Application Number: 10/080,982
Filing Date: February 22, 2002
Appellant(s): JOHNSTON, ROGER L.

EXAMINER'S ANSWER

This is in response to the appeal brief filed October 22, 2007, appealing from the Office action mailed April 20, 2007.

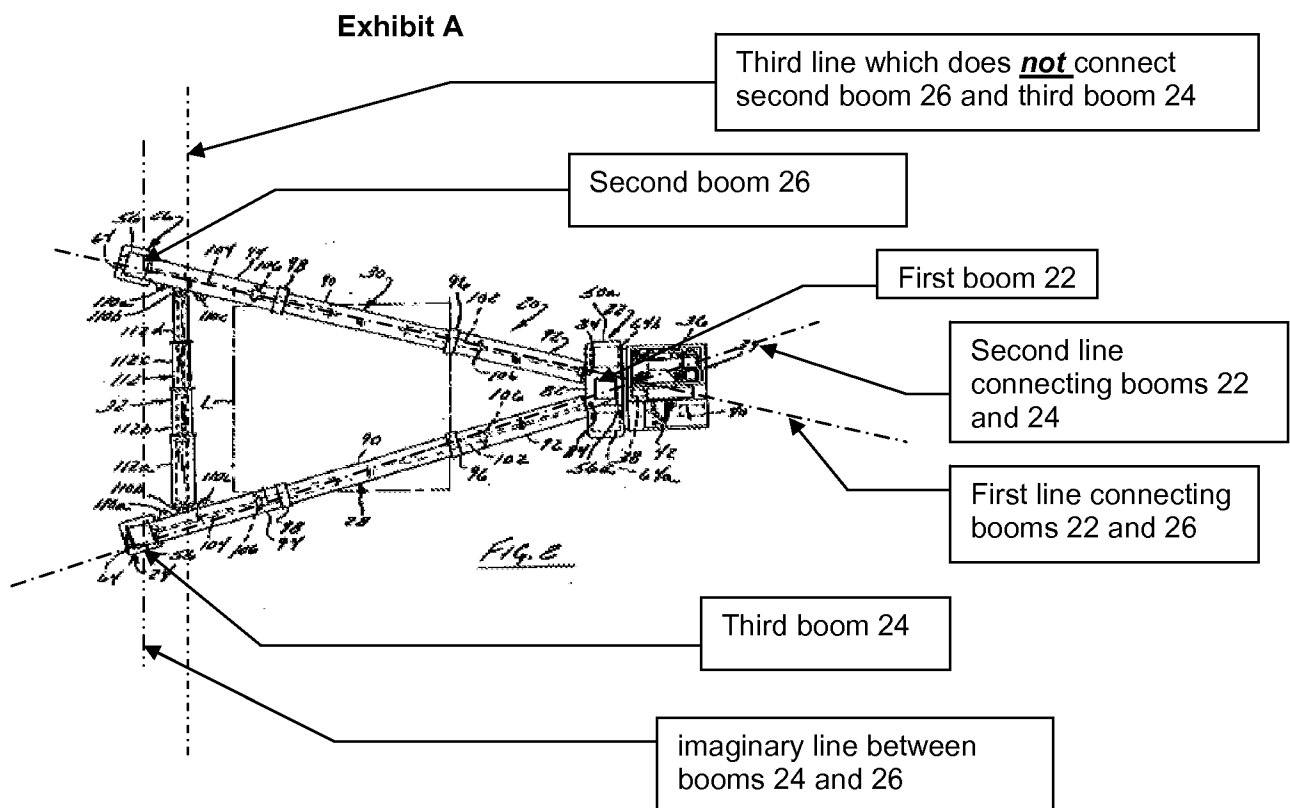
Appellant recites "first, second, and third horizontal lines interconnecting said first, second, and third booms form an acute triangle" in claims 1,13,14,16-18, and the recitation is rejected as "vague and indefinite".

Appellant argues that "Fig. 2 of the application, when viewed in a top plan view, a series of three lines oriented in a horizontal plane such that each line passes through or interconnects two of booms 22, 24, 26, defines the orientation of the lines, and therefore the orientation of the booms in space, to form an acute triangle" (see from line 22 of page 17, to line 3 of page 18).

The argument is incorrect. Fig. 2 only shows two lines interconnecting, a first line connecting booms 22 and 26, and a second line interconnecting booms 22 and 24, but does not show a line interconnecting booms 24 and 26 as shown in Exhibit A. Note that Exhibit A clearly shows that a rear horizontal beam (32) having a line does **not** interconnect the booms 24 and 26. Moreover, the Exhibit A looks like a capital letter "A", instead of "a triangle". Therefore, the recitation of "*first, second, and third horizontal lines interconnecting said first, second, and third booms form an acute triangle*" is unclear as to whether the lines represent "imaginary lines" or "lines of horizontal beams (28, 30, and 32).

The Soviet Union Patent (SU 887,434) (see Exhibit B) discloses

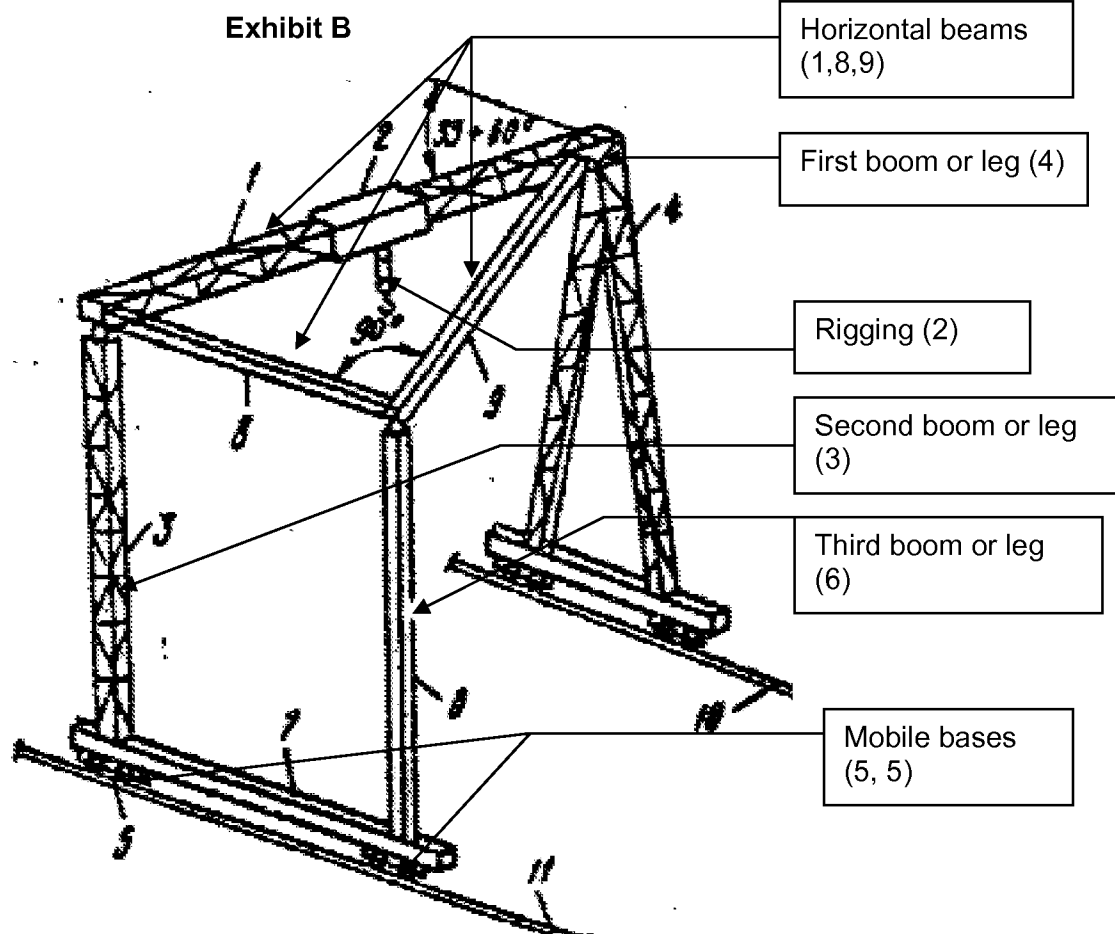
(A) first (4), second (3), and third (6) booms, each boom having a mobile base, the first boom (4) being positioned between the second and third booms (3 and 6),

(B) a plurality of horizontal beams (1, 8, and 9) that functionally interconnect said lift legs, and

(C) rigging (2) that extends downwardly from the beams and that is detachably coupleable to the load after the gantry crane is transported to a position in which at least one of the beams is located over the load.

Exhibit B (figure 2) clearly teaches the claim limitation of “first, second, and third horizontal lines interconnecting said first, second, and third booms form an acute triangle”. The Soviet Union Patent (SU 887,434) does not clearly disclose a mobile base that is rotatable about a vertical axis and each boom having a lift leg that is extendible about the vertical axis.

Exhibit C

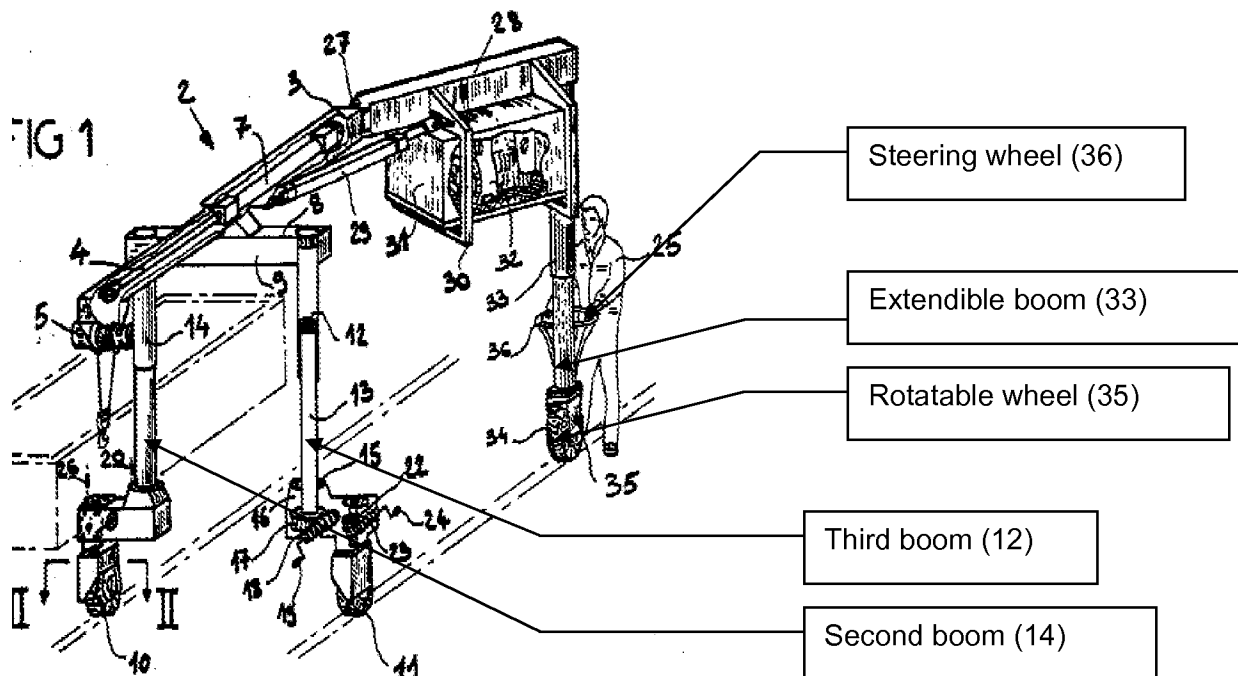
The France Patent (FR 2,597,460) (see Exhibits C and D) teaches two vertical and telescoping posts or legs or booms (12 and 14), adjustable by an acting jack (13), and another "vertical and telescoping post or leg or boom (33), provided with a lifting jack, inside the boom (33), for raising and lowering" (last paragraph of page 7 of English translation), and "a rotatable wheel (34) installed loosely about its vertical axis and receiving a unit hand-controlled steering wheel (36)" (1st paragraph of page 8 of English translation). Note that an operator (25) "controls from his steering position at the steering column 36 shown in the drawing..... He also controls the lifting and lowering control jack of the rear leg 33, The steering column 36 also allows him to guide the idle rear wheel 34" (2nd paragraph of page 8 of English translation).

However, the France Patent (FR 2,597,460) (see Exhibit C) teaches "a vertical and telescoping post or leg or boom (33), provided with a lifting jack, inside the boom (33), for raising and lowering" (last paragraph of page 7 of English translation) and two other vertical and telescoping posts or legs or booms (12 and 14), adjustable by an acting jack (13), and "a rotatable wheel (34) installed loosely about its vertical axis and receiving a unit hand-controlled steering wheel (36)" (1st paragraph of page 8 of English translation).

Exhibit D

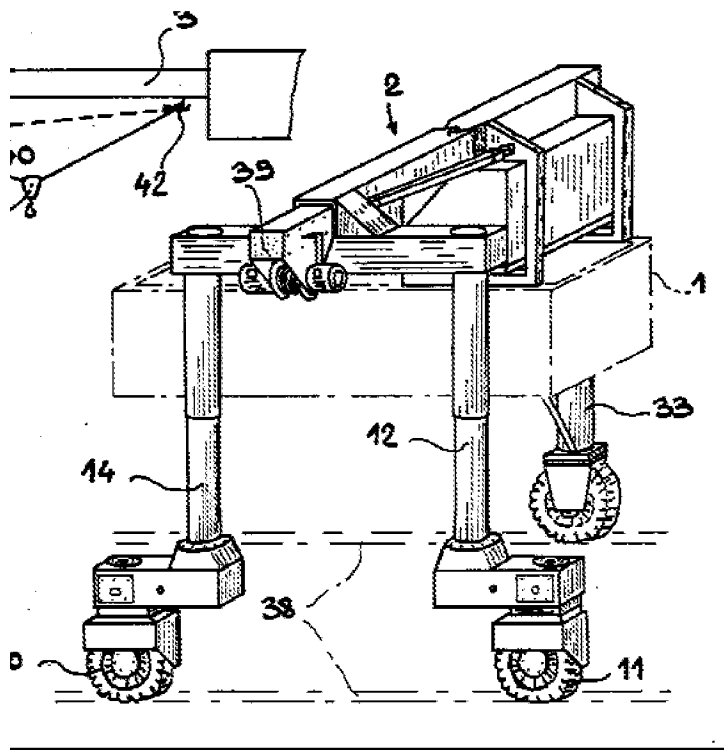
It is pointed out that the France Patent's gantry is capable of being oriented at different positions as shown in figures 1, 3, 4, and 5.

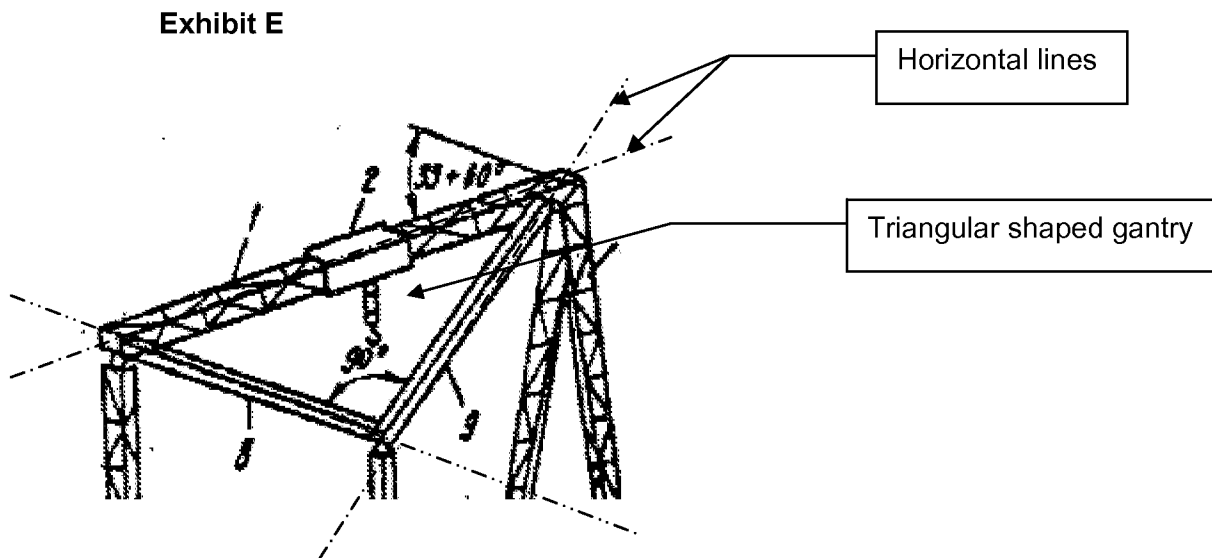
The argument is incorrect and not persuasive. Claim 1, lines 7-8, recites, "first, second, and third horizontal lines interconnecting said first, second, and third booms form an acute triangle". It is pointed out that Fig. 2 of the instant application (Exhibit A) looks like a capital letter "A", instead of "a triangle".

Exhibit E teaches "first, second, and third horizontal lines interconnecting said first, second, and third booms form an acute triangle" as recited in claim 1.

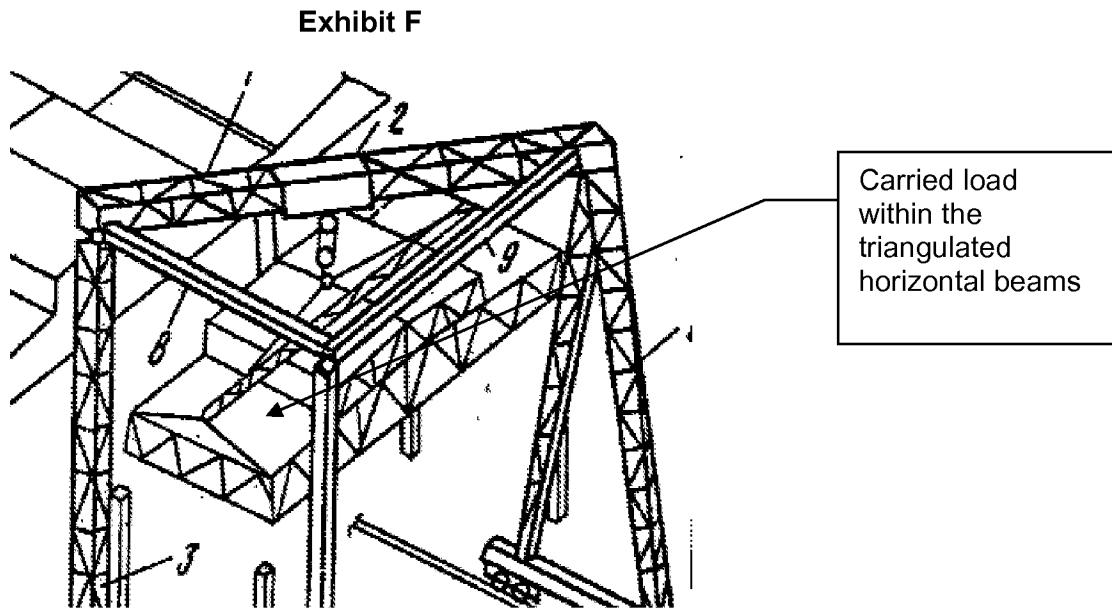
The argument is not persuasive. **Exhibit F** (Fig. 2 of the Soviet Union Patent '434) teaches that a load is being carried on a horizontal beam (1) wherein the carried load is located substantially at the center of the triangular shape gantry.

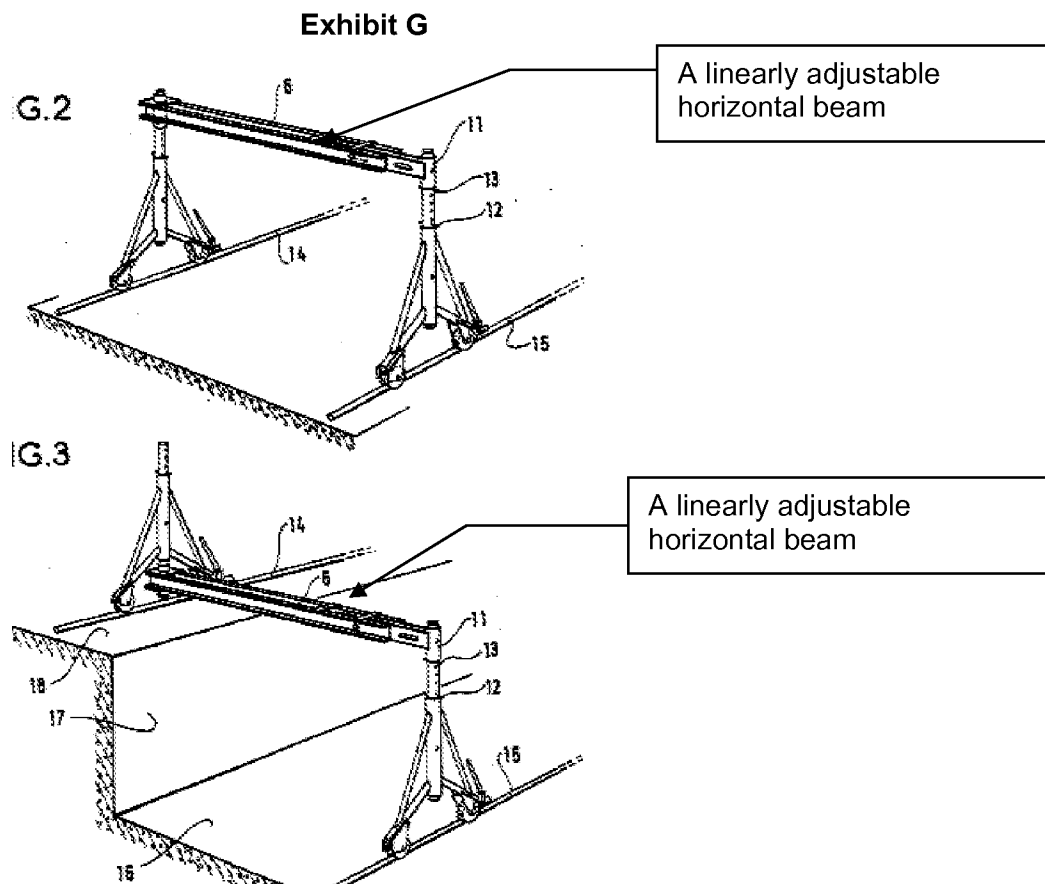
The Soviet Union Patent (SU 887,434) in view of the France Patent (FR 2,597,460) shows "a plurality of horizontal beams (1, 8, and 9) that functionally interconnect said lifting legs", but does not clearly teach that "at least one of the beams is linearly extendable to increase the horizontal spacing between two of said booms".

The France Patent (FR 2420502) (see **Exhibit G**) teaches a gantry having a horizontal beam, which is adjustable in length. The English translation clearly describes "*As one can see in figures 2, 3, and 4, the beams 6, 23, and 24 are telescoped and therefore one can adjust their length*" in the last two lines of page 7.

Exhibit H

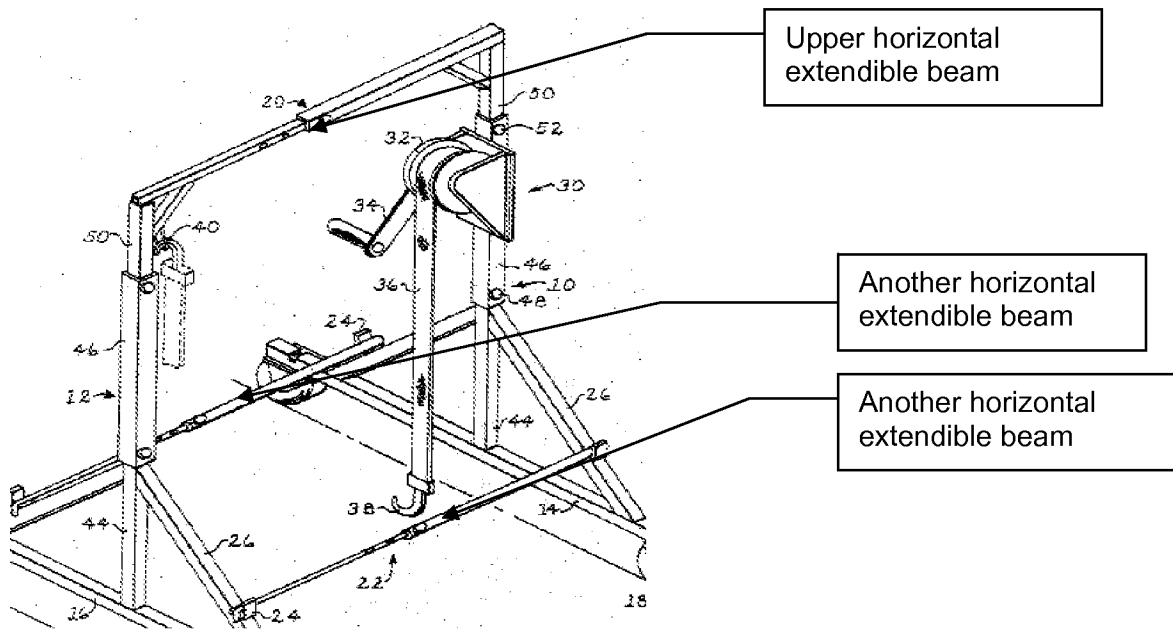
Gonzales (3,831,791) (see **Exhibit H**) also teaches a mobile lift having a *horizontal adjustable beam* (20) supported by two vertical legs (10 and 12) to provide an adjustable spacing for convenience to a user. Thus, to those skilled in the gantry art would provide an adjustable horizontal beam, instead of a fixed beam, on the Soviet Union Patent (SU 887,434) as taught by Gonzales (3,831,791) to employ an adjustable spacing providing flexibility to a user.

Exhibit I

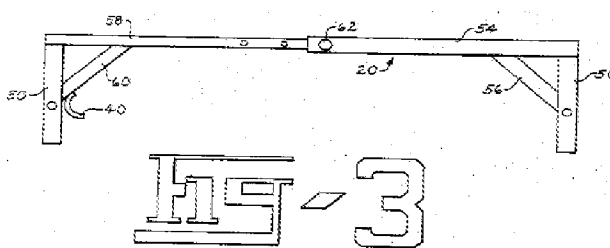
Appellant is silent about Gonzales (3,831,791). Fig. 3 of Gonzales (3,831,791) (**see Exhibit I**) also teaches a telescoping horizontal beam having one outer tube (54) slidable over at least one inner tube (58). **Exhibit H** (Fig. 1 of Gonzales (3,831,791) teaches a plurality of adjustable horizontal beams (20, 22, 22) to provide adjustable spacing between the vertical legs (10, 12).

Exhibit J

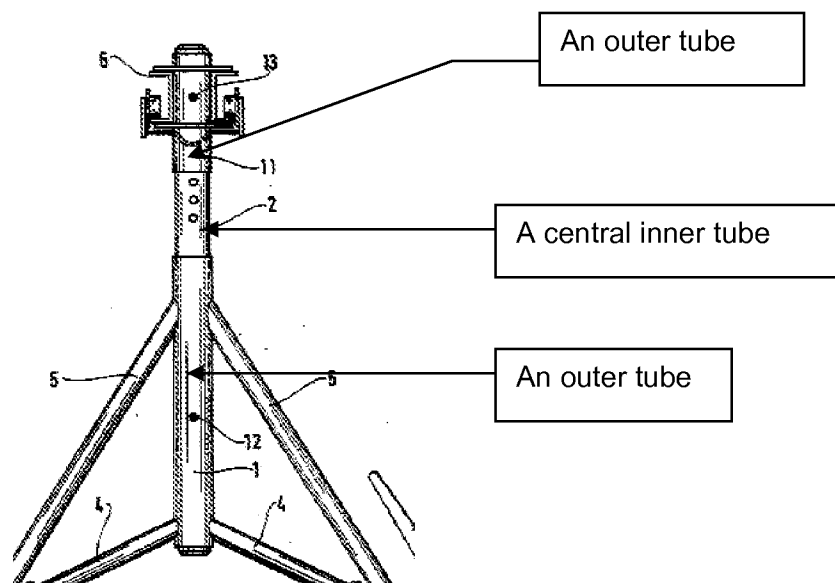
Figures 2 and 3 of the France Patent (FR 2420502) teach a telescoping horizontal beam having a first outer tube (6) slidable over at least one inner tube, but does not teach another outer tube (or a second tube) **being positioned or oriented** the other end of the inner tube. However, Fig. 1 of the France Patent (FR 2420502) (**see Exhibit J**) teaches an inner tube (2) or shaft positioned between a first outer tube (11) and a second outer tube (1). Thus, to those skilled in the lifting crane art would provide the position of the inner tube between two outer tubes on the horizontal beams of the Soviet Union Patent (SU 887,434) as taught by the France Patent (FR 2420502) is predictable to provide flexibility of linearly securely extending or retracting the beams.

Exhibit K

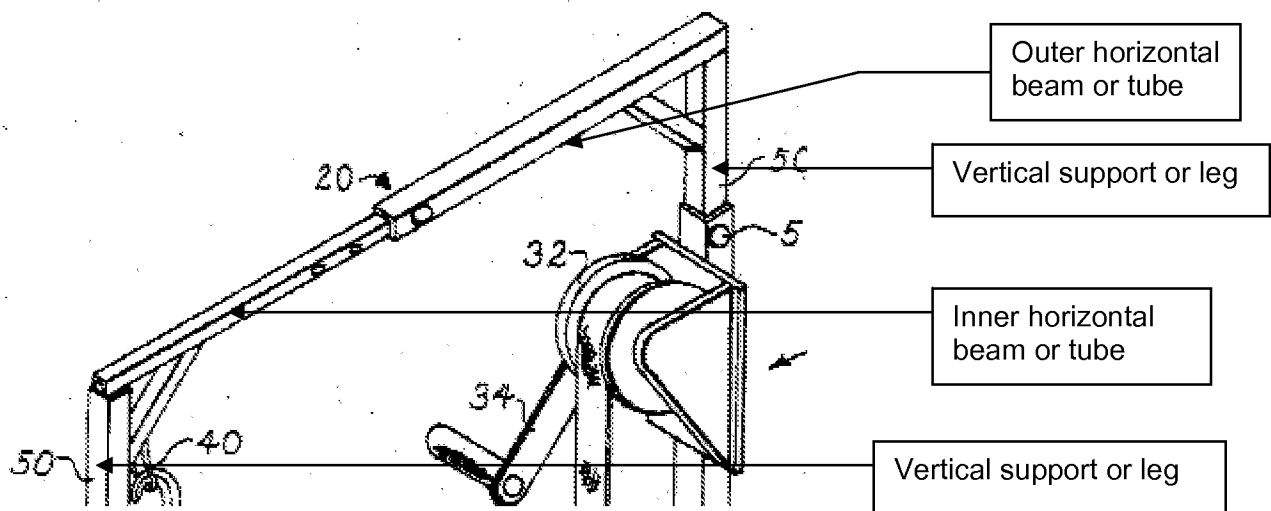
Fig. 3 of Gonzales (3,831,791) (**see Exhibit K**) also teaches a telescoping horizontal beam having a first outer tube (54) slidable over at least one inner tube (58) wherein the

Either the France Patent (FR 2420502) or Gonzales (3,831,791) does not teach another outer tube (or a second tube) **being positioned or oriented** the other end of the inner tube.

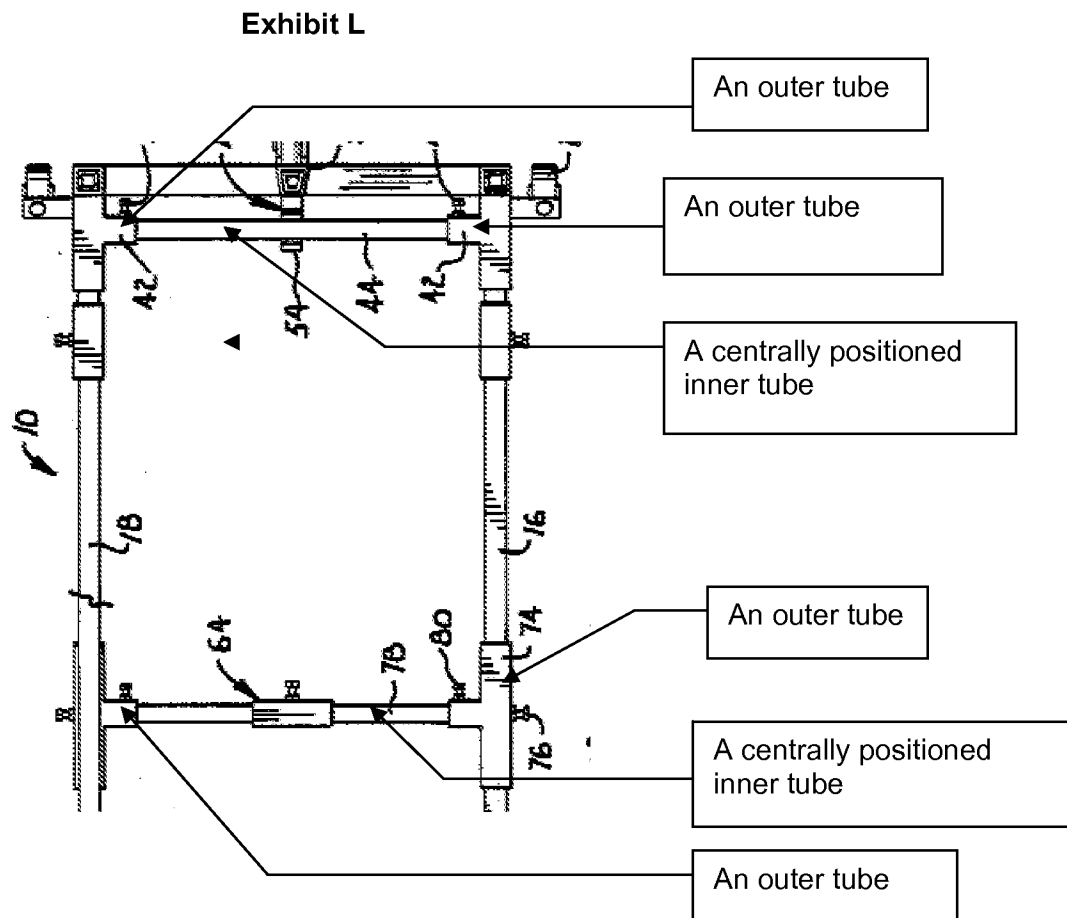
However, Brower (4,897,011) (**see Exhibit L**) teaches a horizontal beam having an inner tube (78, 44) **positioned** or **oriented** between two outer tubes, a first outer tube and a second outer tube.
